DART AEROSPACE LTD	Work Order:	95327
Description: Crosstube Assembly	Part Number:	D206-667-243
Inspection Dwg: D206-667-243 Rev: C		Page 1 of 2

DESIGN	9	DART AEROSPACE LTD	
DRAWN	RF	HAWKESBURY, ONTARIO, CANADA	
CHECKED	CP	DRAWING NO.	REV. C
MFG. APPR.	EP	D206-667-243	SHEET 3 OF 4
APPROVED	UP	TITLE	SCALE
DE APPR.	UP	CROSSTUBE ASS'Y (206L HIGH AFT)	NTS
DATE	08.11.06	COPYRIGHT © 2000 BY DART AEROSPACE LTD THIS DOCUMENT IS PRIVATE AND CONFIDENTIAL, AND IS SUPPLIED ON THE EXPRESS CONDITION THAT IT IS NOT TO BE USED FOR ANY PURPOSE OR COPIED OR COMMUNICATED TO ANY OTHER PERSON WITHOUT WRITTEN PERMISSION FROM DART AEROSPACE LTD

DRAWING NO. D206-667-243	TITLE CROSSTUBE ASS'Y (206L HIGH AFT)	REV. C	DART AEROSPACE LTD ENGINEERING ORDER		D.E.O. NO. D206-667-243-C-1	SHEET NO. SHEET 1 OF 1	SCALE NTS
DRAWN <i>q</i>	CHECKED <i>ASS</i>	MFG. APPR. <i>RB</i>	APPROVED <i>MD</i>		DE APPR. <i>#</i>		
DATE 11.07.15	DATE 11.07.20	DATE 11.07.21	DATE 11/07/21		DATE 11.07.21

PURPOSE:

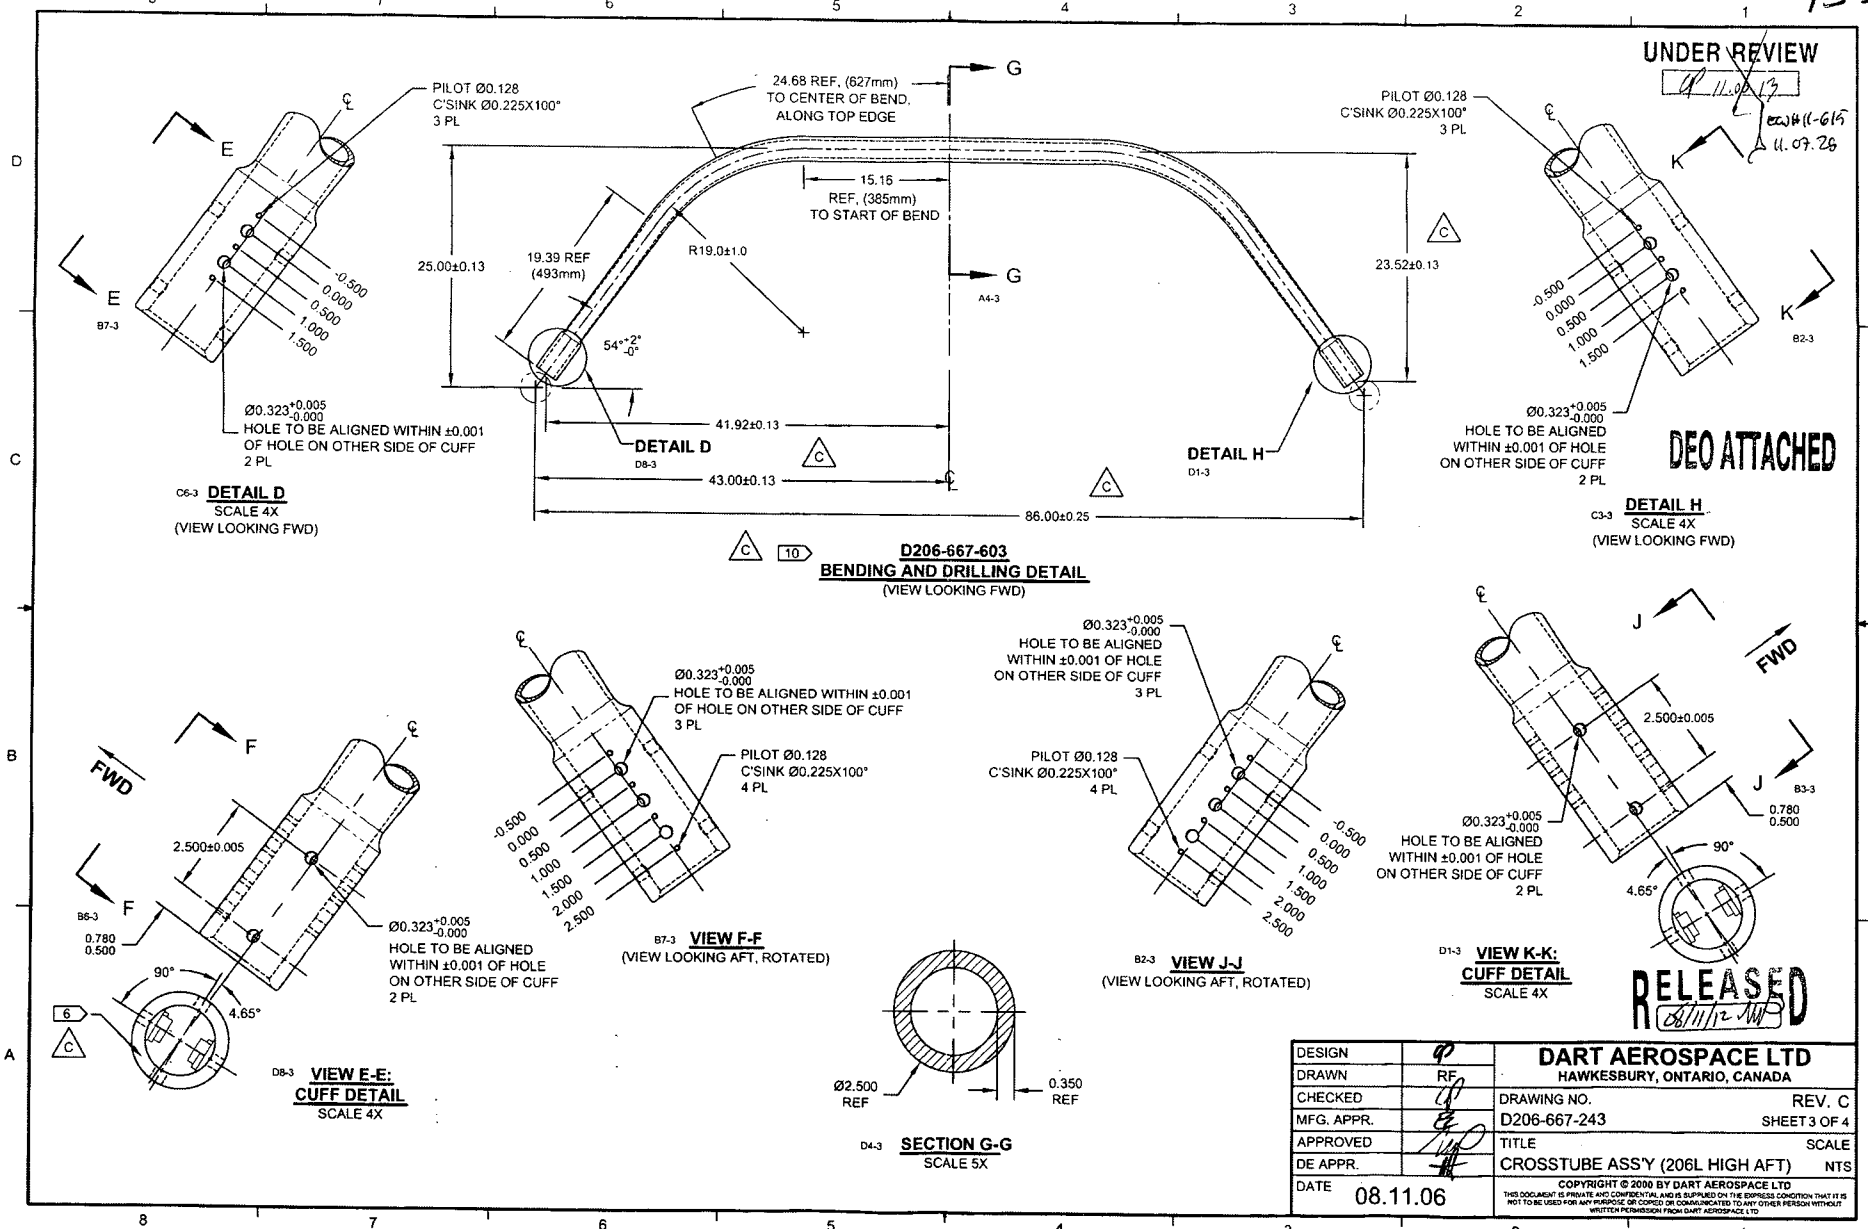
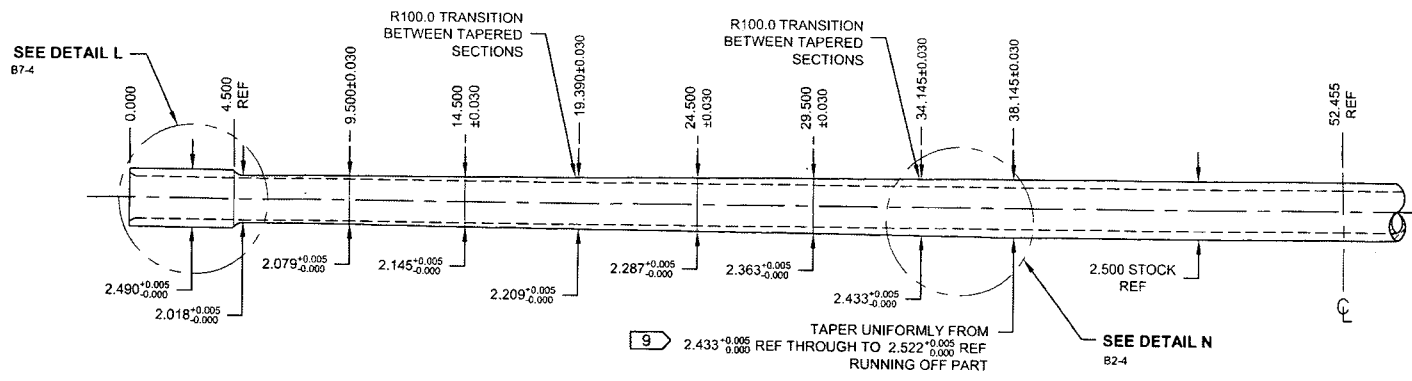
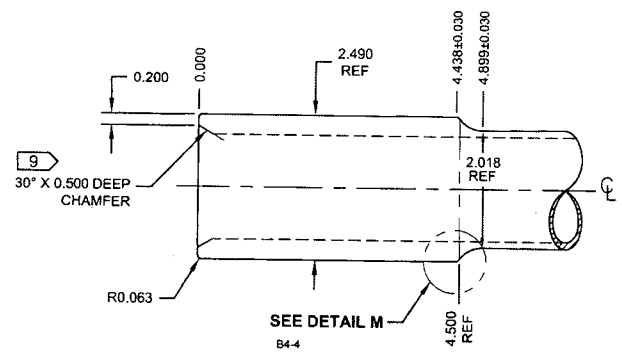
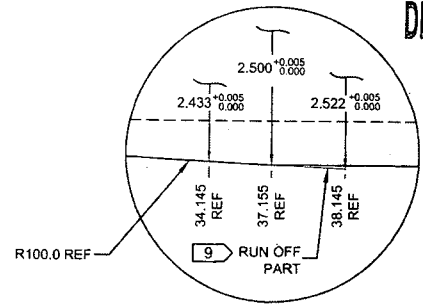
C	REVISE GENERAL NOTES/PART LIST (ZN D7-1); REORGANIZED VIEWS AND REFORMATTED DRAWING TO CURRENT STANDARDS. D3595-063-450 WAS D2856-400-773 (ZN D6-2 & A5-2); REMOVED REF. & ADD TOLERANCES (ZN 4-3, C5-3, D3-3); RELOCATED FLAG #6 (ZN A8-3) PER NCR 210; MOVED TURNING DETAIL & UPDATED TOLERANCE TO SHEET 4.	RF	08.11.06
B	ADD HOLES AND NUT PLATES FOR COMPATABILITY WITH BHT/AA SKUDTUBES	PH	05.07.26
A	NEW ISSUE	CP	00.11.17
REV.	DESCRIPTION	BY	DATE
DESIGN	RF	DART AEROSPACE LTD HAWKESBURY, ONTARIO, CANADA	
DRAWN	RF	DRAWING NO. D206-667-243	REV. C SHEET 1 OF 4
CHECKED	RF	TITLE CROSSTUBE ASS'Y (206L HIGH AFT)	SCALE NTS
MFG. APPR.	RF	COPYRIGHT © 2000 BY DART AEROSPACE LTD THIS DOCUMENT IS PRIVATE AND CONFIDENTIAL AND IS SUPPLIED ON THE EXPRESS CONDITION THAT IT IS NOT TO BE USED FOR ANY PURPOSE OR COPIED OR REPRODUCED IN ANY FORM OR BY ANY MEANS WITHOUT WRITTEN PERMISSION FROM DART AEROSPACE LTD.	
APPROVED	RF	DATE 08.11.06
